Mitsubishi Motors North America, Inc.

TECHNICAL SERVICE BULLETIN

REAR SHOCK ABSORBER FLUID LEAK

No: TSB-24-34-001

SEC. 431

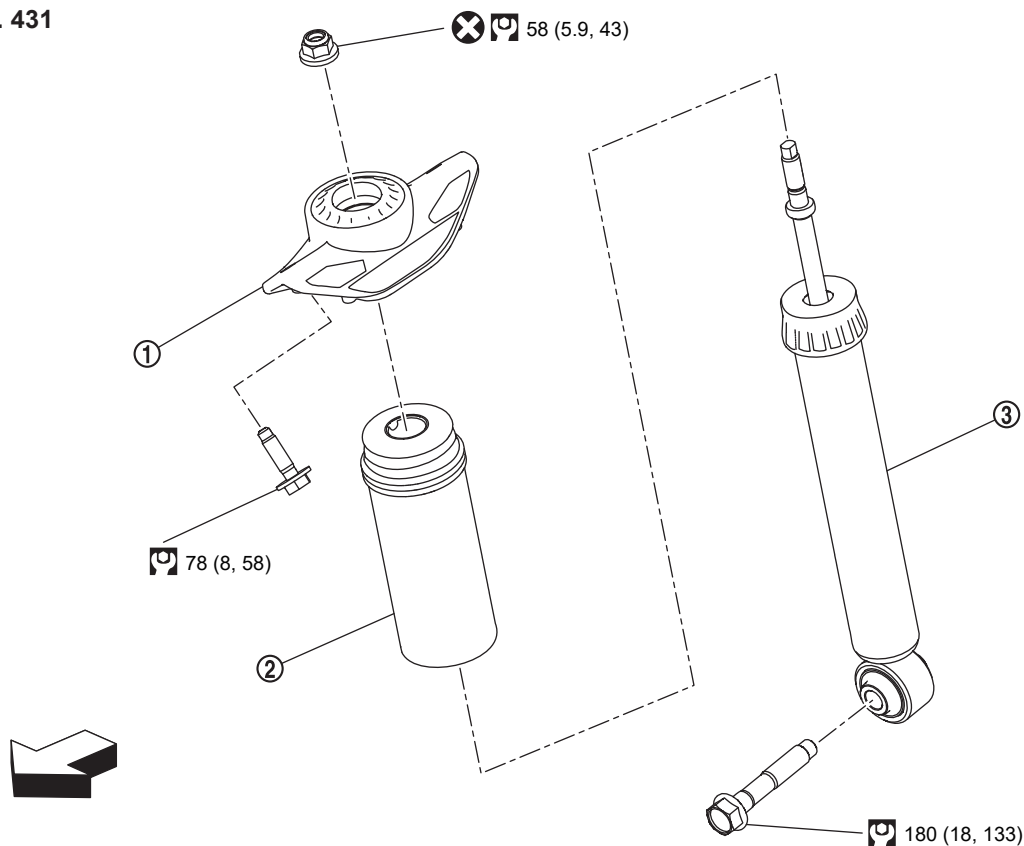
- Adding the CAP-RR SHOCK ABS will prevent water/substance intrusion
- INSUL ASSY-SHOCK ABS MTG shape has been changed
- A groove has been added on INSUL ASSY-SHOCK ABS for mounting a rubber cap
- The added rubber cap on top of the INSUL ASSY-SHOCK ABS MTG will provide protection from water and other substances

On a customer complaint basis replace the old shock absorber with the new SHOCK ABSORBER, RR SUSP and INSULATOR, RR SHOCK ABSORBER (both the left and right), then install CAP, RR SHOCK ABSORBER.

Cap Installation Guide

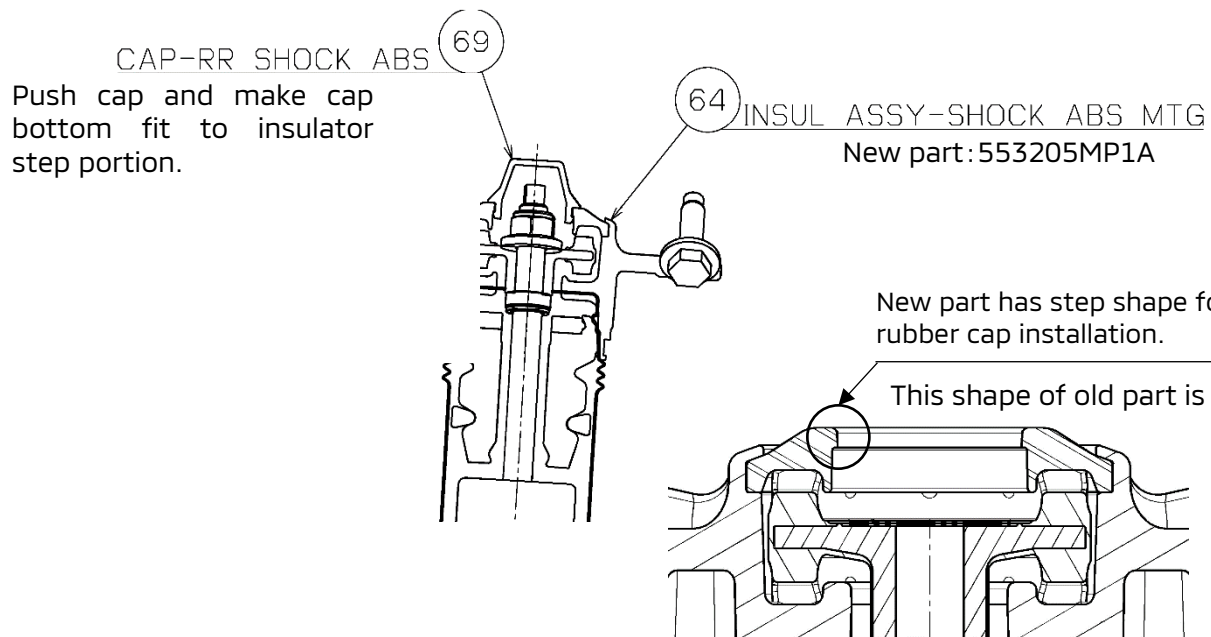
Do not replace the parts with this combination: Old insulator with new rubber cap. Attaching the rubber cap to an old insulator causes the rubber cap to come off easily.

Additional part : 562045MP0B
